MAJOR REPAIR AND ALTERATION (Airframe, Powerplant, Propeller, or Appliance)

1. Aircraft	Make <p style="text-align: center;">Piper</p>	Model <p style="text-align: center;">PA-22-150</p>
	Serial No. <p style="text-align: center;">22-5185</p>	Nationality and Registration Mark <p style="text-align: center;">N7424D</p>
2. Owner	Name (As shown on registration certificate) <p style="text-align: center;">Ralph R. Gutowski</p>	Address (As shown on registration certificate) <p style="text-align: center;">8 Ives Woods Drive Oxford, OH 45056</p>

4. Brief Description of Project **REROUTE FUEL LINE FROM RIGHT TANK REAR OUTLET TO IMPROVE FUEL FLOW & SAFETY MARGIN.**

Figure 1

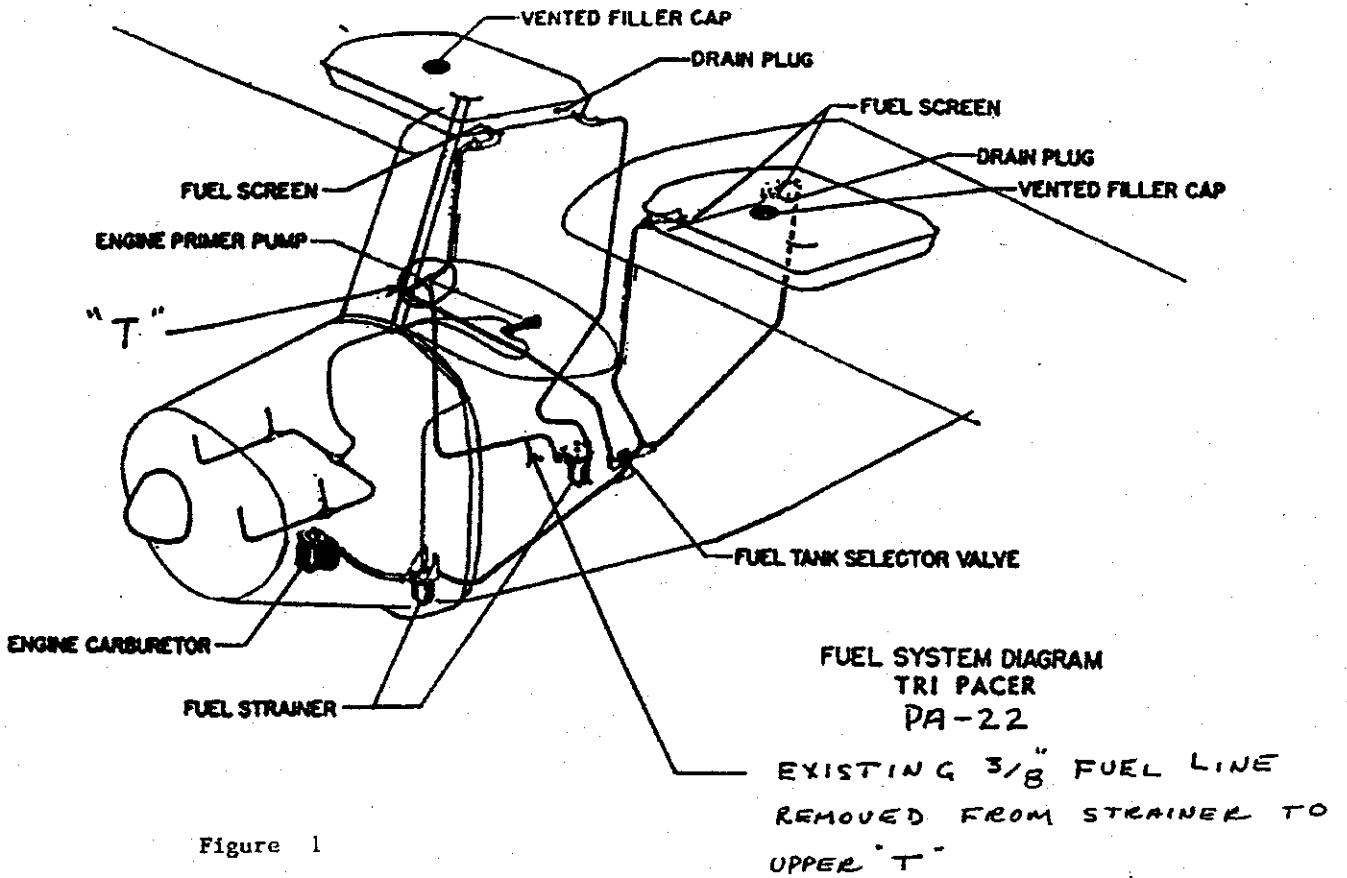
1. Removed existing 3/8" diameter fuel line from gascolator, right side, bottom floor, to AN "T" located in front of right upper side doorpost under instrument panel (see figure 1, sheet A).

Figure 2

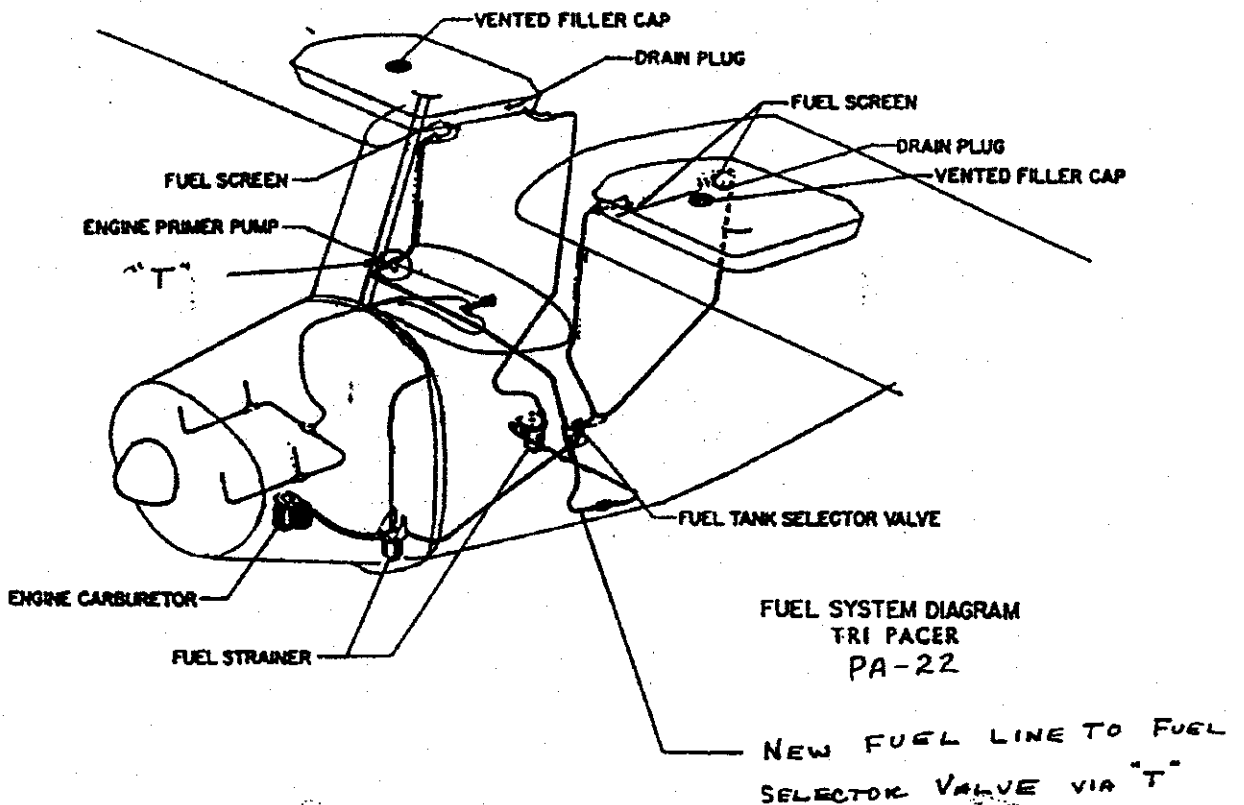
2. Installed AN929 cap at "T" fitting (see figure 2, sheet A).
3. Installed a new 3/8" - 3003-0 (0.375" x 0.035") Aluminum tubing fuel line from right floor gascolator, parallel to tubular fuselage crossmember and parallel to left cabin floor bulkhead, to existing fuel valve using AN826 (MS20826) Tee-fitting with AN818/AN819 nut-sleeve combination (see figure 2, sheet A).

Figure 2

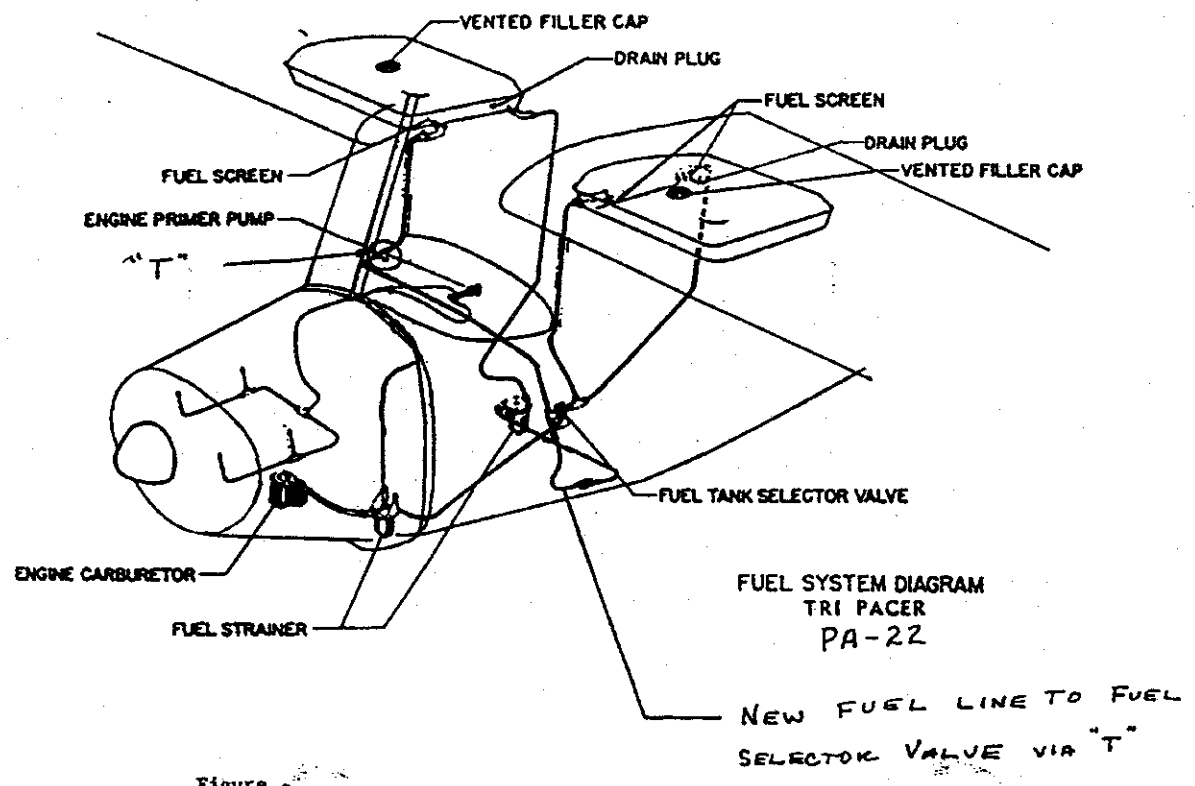
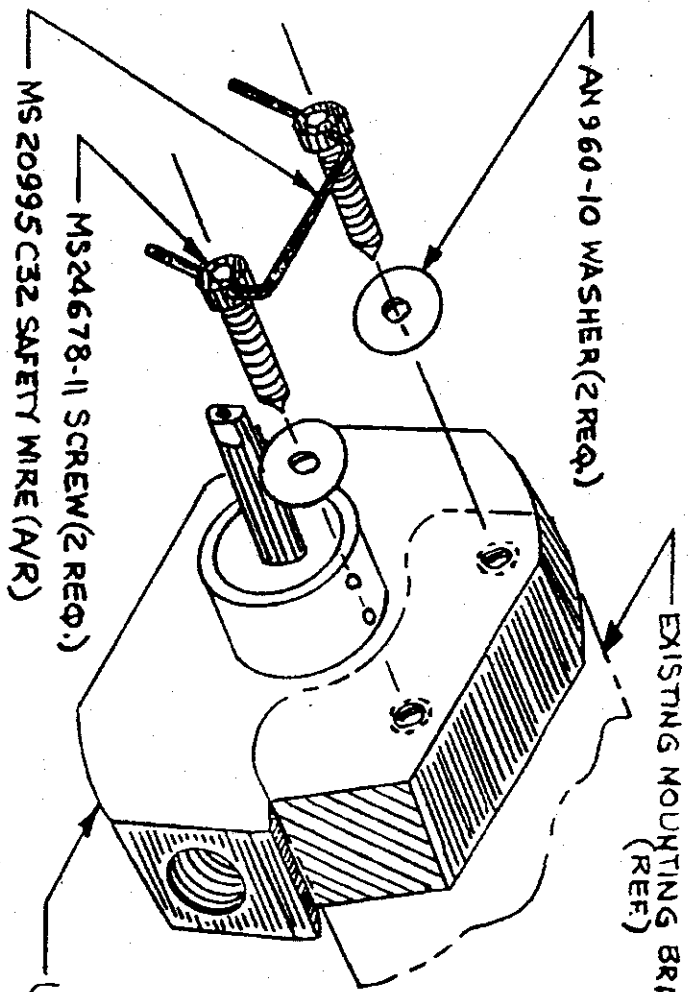
1. Removed existing 3/8" Dia. fuel line from gas collator, right side, bottom of floor, to AN "T" located in front of right upper side doorpost under instrument panel.
2. Installed A.N. cap at lower "T" fitting. (See Figure 2, sheet A).
3. Installed a new 3/8" - 5051 Alum tubing. fuel line from right floor gas collator to new UNIVAR FUEL VALVE # U-491-947A, VIA. behind tubular Fuselage crossmember, and parallel to left cabin floor bulkhead using AN Fittings. (See Figure 2, sheet B).
4. Test fuel system for leaks and found none.
5. Test fuel system for flow of fuel and found a difference of 8% between right and left tank as compared to 18% before modification, for a net gain of 225% improvement. System now has a gravity fuel flow of 38 GAL/HR.
6. No significant change in weight and balance noted.
